## Planning Commission Staff Report

### ITEM 3: 150 PLACERVILLE DRIVE – SPR90-11-R2 – KWIK SERV

**Request:** To consider Site Plan Review (SPR) 90-11-R2, an amendment to the Site Plan Review to allow for business signs; new exterior paint scheme to re-image an existing convenience store with gas pumps (former Shell branded facility) to a Kwik Serv branded site; to change the canopy lights with flush mounted lights; and, to consider a categorical exemption from the California Environmental Quality Act (CEQA) per CEQA Guidelines Section 15301, "Existing Facilities."

EXISTING D/F PRICE/ID SIGN

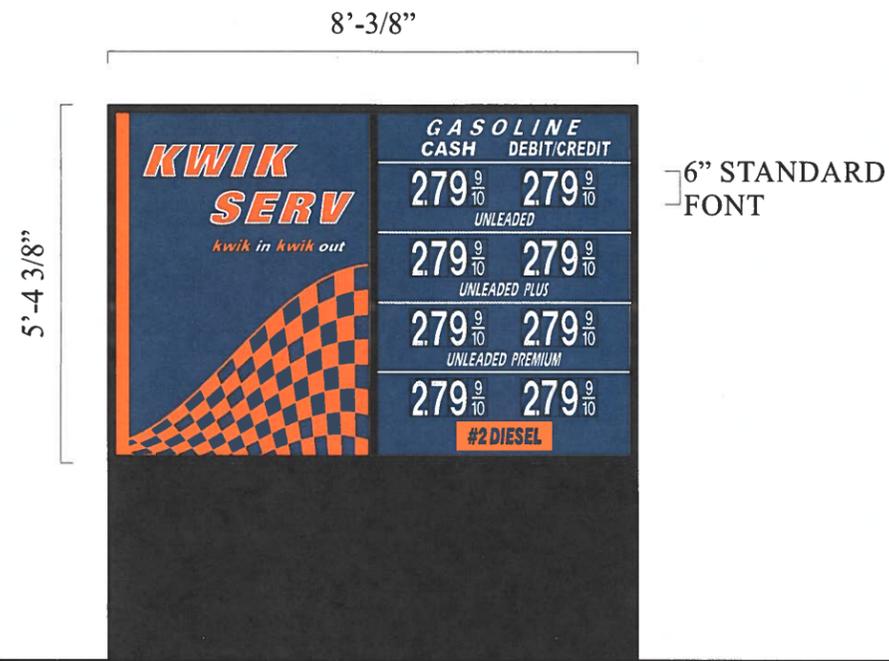
Proposed sign faces for the pump canopy signs (Sign #2 and Sign #3) on the canopy's north and south elevations are designed so that the sign text or sign copy would be illuminated at night and not the opaque background. The refaced ground sign cabinet (Sign #1) near the southwest corner of the site is conditioned so that the background of the sign copy will not illuminate, only the price numerals and the sign copy may illuminate at night. Signs are consistent, as conditioned, with PZC 10-4-17(G)5d involving internal illumination.

6. New internally illuminated wall cabinet signs authorized under SPR90-11-R2 shall conform to the City's Regulations for On-Premise Signs (PZC 10-4-17(G)), requiring the sign shall have an opaque background and be designed so that only the lettering or advertising copy is visible at night.
